RE: Cedar Bay Cogeneration Facility
Co-firing Petroleum Coke with Coal
PSD-FL-137A Revision
DEP File No. 0310337-005-AC

RE: REQUEST FOR ADDITIONAL INFORMATION
CEDAR BAY COGENERATION FACILITY
CO-FIRING PETROLEUM COKE WITH COAL
FILE NO. PA 88-24 (PSD-FL-137)

**ADDITIONAL INFORMATION FOR
CO-FIRING PETROLEUM COKE WITH COAL**

**File No. PA 88-24 (PSD-FL-137)
Cedar Bay Cogenerating Project**

Figure 3
Process Flow Diagram for Petroleum Coke Unloading
Cedar Bay Cogeneration Facility
Jacksonville, Florida

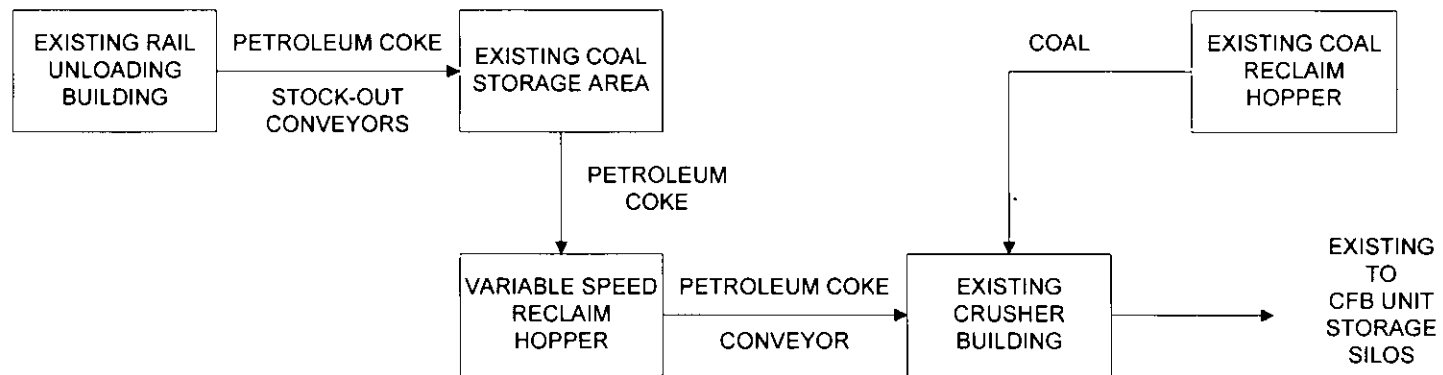
Additional Information: Comment acknowledged. The actual usage of limestone is presented in Table 1. Table 6 presents a update of the material usage for the project based on 35 percent petroleum coke co-fired with coal. The information on the fugitive emissions calculation presented in Appendix B of the application were based on an increase using 35 percent of the coal utilization and the use of a truck dump. A truck dump is no longer planned. Petroleum coke will be received within the enclosed coal unloading building. Since this building is partially enclosed and has a water spray system for controlling fugitive dust, overall emissions will be lower than those presented in the application. The limestone usage was based on the projection of Foster Wheeler for 35 percent petroleum coke with coal. Using this approach, these fugitive emissions estimates are greater than those using the revised calculations (e.g., 22,500 lb/hr/unit compared to a calculated of 19,000 lb/hr/unit in Table 6). Figure 3 has been updated to reflect the change in the use of the coal unloading building.
